Lloyd's Register of Shipping.

Ship's Name "W A L B O R G"

Official No. 2969

Memorandum of alterations reported since ship was surveyed for assignment of Load Lines in Hälsingborg.

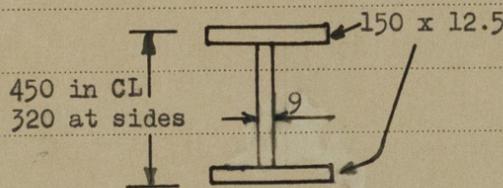
The two beams in No.3 hatch replaced by new beams as per sketch.
